Detailed Site Plan Temple Hills Storage

DET-2023-002

STAFF REPORT

SUBJECT: Detailed Site Plan DET-2023-002
Type 2 Tree Conservation Plan TCP2-051-2023
Temple Hills Storage

Figure 2: Entrance Sign

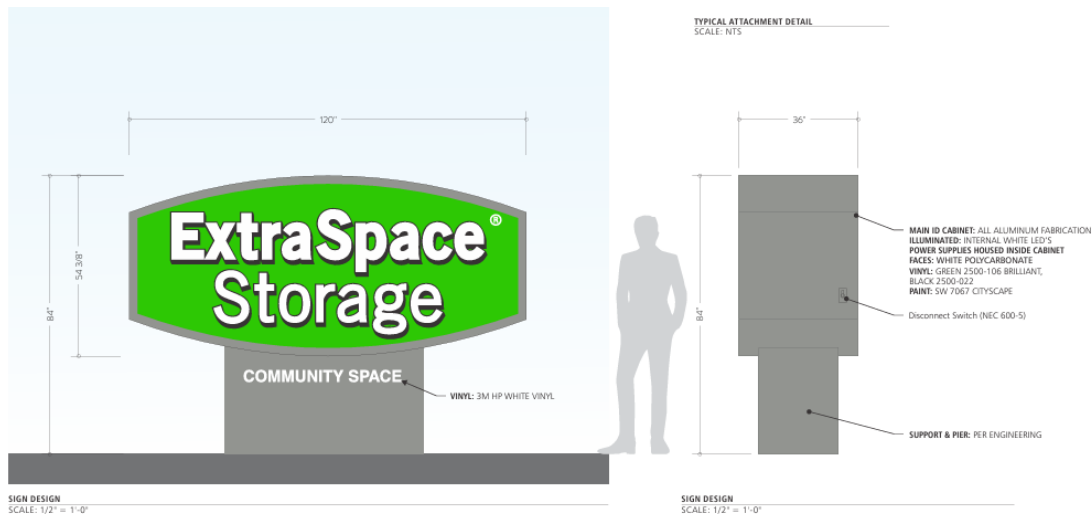
2. **Signage.** The proposed gateway sign will be appropriately landscaped at the base of the sign. Said sign also conforms to the above location, number, area, height, and materials requirements/standards as follows:

Location – Southeast portion of the site.

Sign Area – 45.3 SF

Height – 7'-0" to the top of the sign.

Materials – Aluminum, vinyl, low maintenance and durable.

Figure 3: Schematic Section illustrating Neighborhood Compatibility

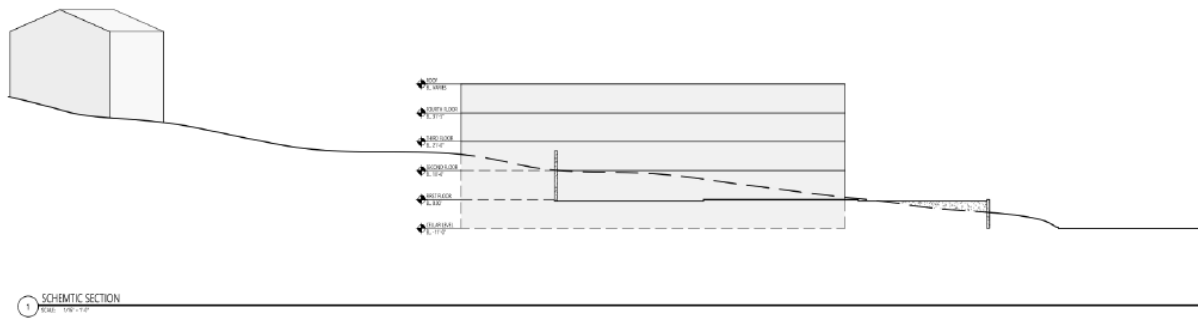
The proposed development meets the height restrictions contained in 27-61203(a)(2). Due to significant topographical conditions on the property, the proposed

building has a 2.5-story height (25 feet, 10 inches) for the portion within the 50-foot–150-foot transitional area, adjacent to the single-family home to the east. Beyond this area, the falling topography of the property allows the building height to climb to 4 stories (47 feet), once beyond the 200-foot transitional area.
